State of Washington
DEPARTMENT OF HEALTH

Subject: Westside Water Association, ID# 94950
King County
Routine Sanitary Survey 2018

ROUTINE SANITARY SURVEY REPORT

WESTSIDE WATER ASSOCIATION

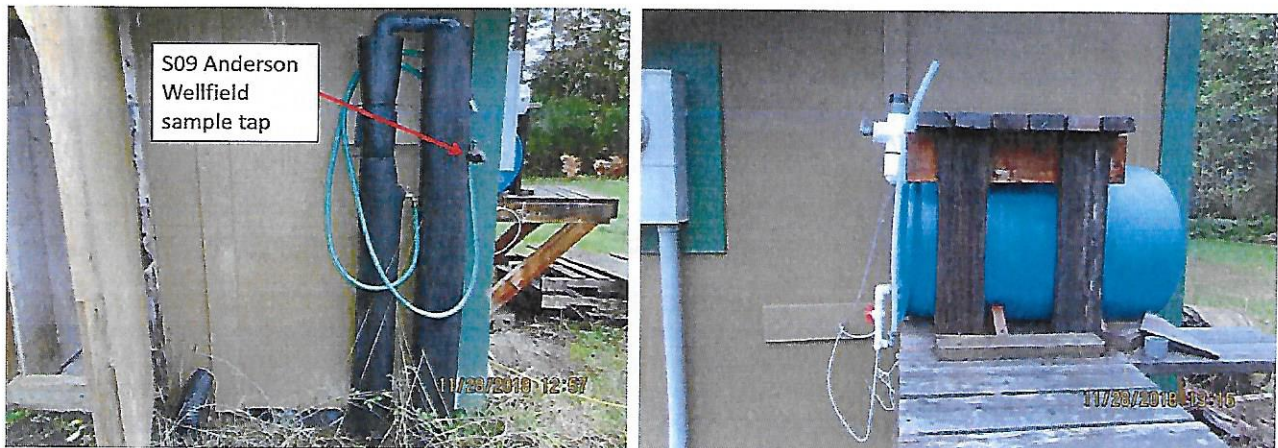
Figure 2. (Left) Anderson Well (S07) wellhead has good seals and screens, and a sample tap. Anderson Well #2 (S08) and meter shown here entering the building behind S07. (Right) Anderson Well #2 (S08) wellhead has good seals and screens, and a sample tap. The enclosure is tightly sealed and effective at keeping critters out. It is not clear how air gets in the enclosure.
